NOTICE UNDER SCHEDULE VI CHAPTER XI, RULE 2 (I) OF
THE CITY OF KARACHI MUNICIPAL ACT 1933.Karachi 22nd August 1936

PLANSHOWING ADDITION'S & ALTERATION'S
ON EXISTING BUILDING PLOT N^o 54.

SHEET M.M. 4.
MUCHI MIANEE QUARTER

With reference to your application dated 22nd. August 1936
with a plan for the proposed building/additions and alterations on plot
No. 54, Survey Sheet No. M.K.4, Machi Tiani Quarter
I have to request you to comply with the following requirements:—

GROUNDPLAN

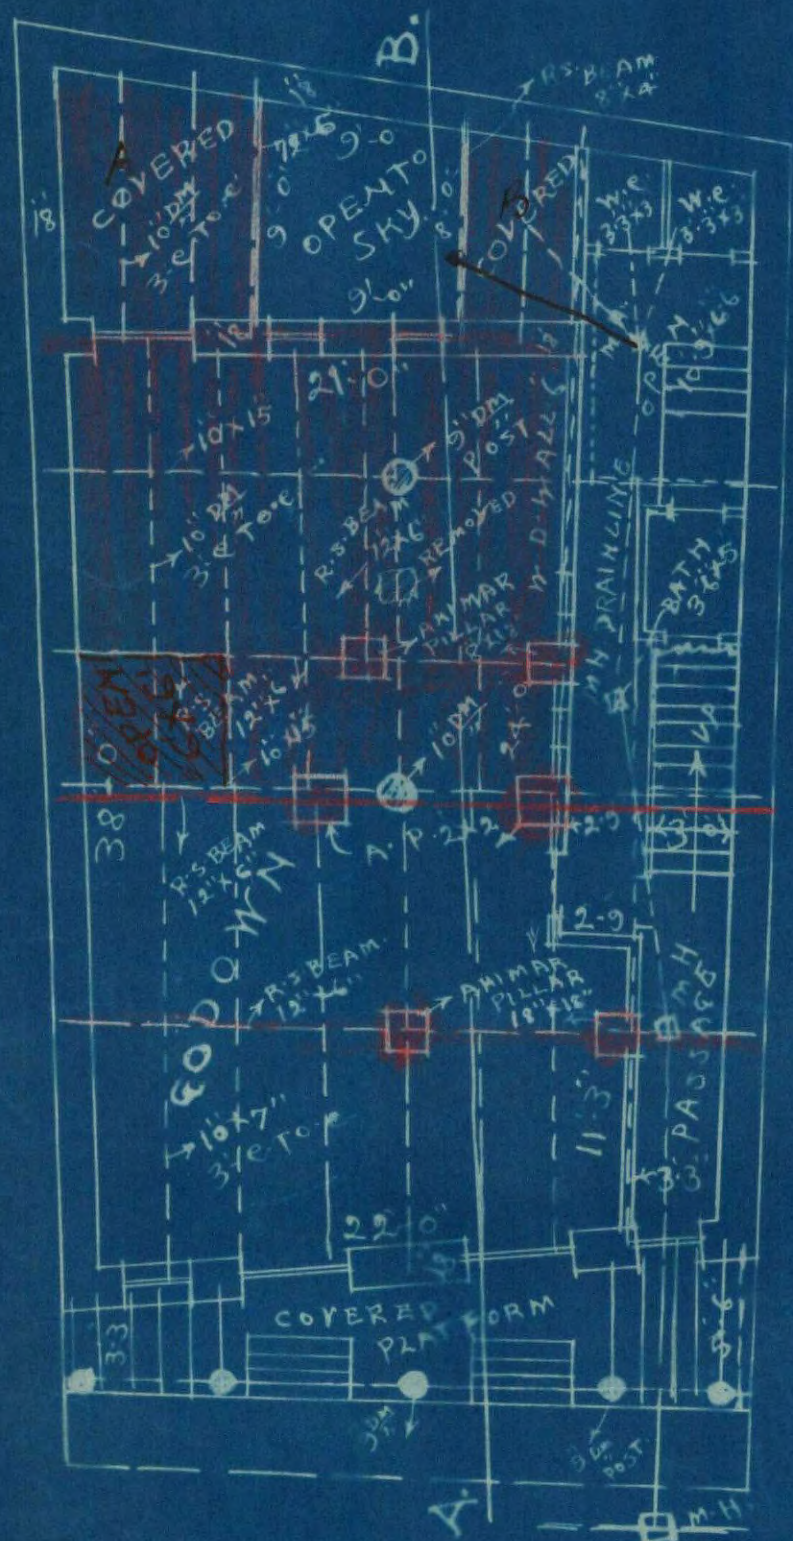
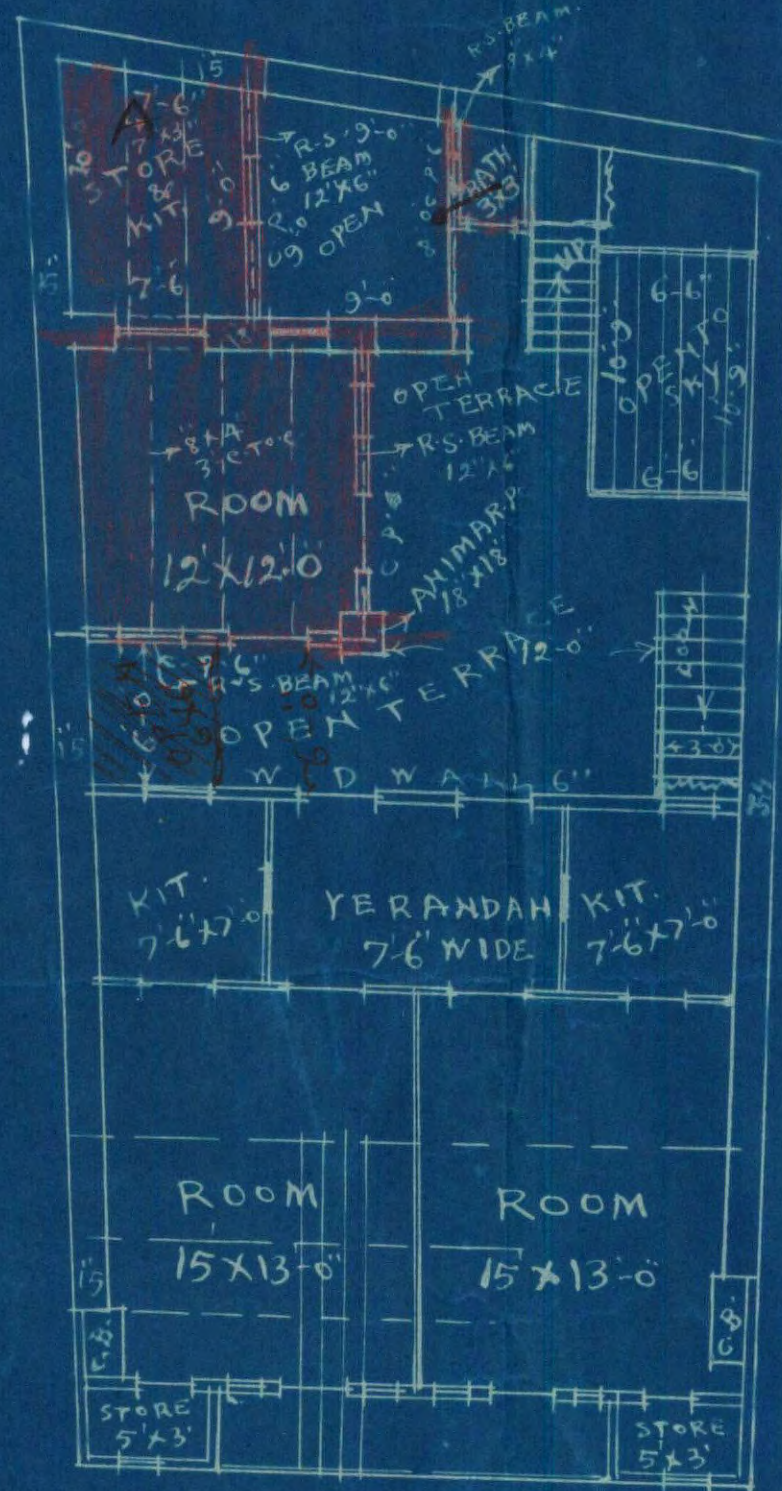
1. The open spaces in front of the W.C.s must be ^{unobstructed} ~~constru~~
and according to rules, and should be at least 100 sq. ft.
with the least width of 10'.
2. Neater plans must be submitted.
3. Plans will not be approved till the question of encroachment is settled.
4. Room A is less than 100 sq ft. cannot be allowed. To ensure through ventilation area B should also be open to sky.

1. The open spaces ^{in front of the WC's} must be unsubdivided and according to rules & should be at least 100 sq ft with the least width of 10'

2. It is not understood why so many 'ornamental' pillars are proposed. A simpler construction be adopted -

5. 3'3" width of the main passage is inadequate. It will be increased

Rooms A is less than 100 sq ft can not be allowed — To ensure through ventilation area B should also be open to sky

1. The open space in front of the house is an old structure which is not shown in this plan and request that it may be allowed as it exists which is more than 64 sq ft according to rule as was explained to you personally this day and as suggested by you the back open space is increased by 210".
2. Heater plans will be submitted when this plan is approved personally.
3. As decided by C. O. the plans may be approved.
4. Room A is kitchen and is not a living room hence it may be less than 100 sq ft. The open space is increased at the back as suggested by you. The plans be approved.

Re: requirement, to state
that he saw you personally &
that you have agreed to a 2'
increase in the open space
as shown in the plan

Re: no. 4. he states that
the room in question is a
kitchen and hence 100 sq ft
disputed area should not
be insisted upon.

Re: 4 let the man be
corrected accordingly
& then pass the case
b. l. r.
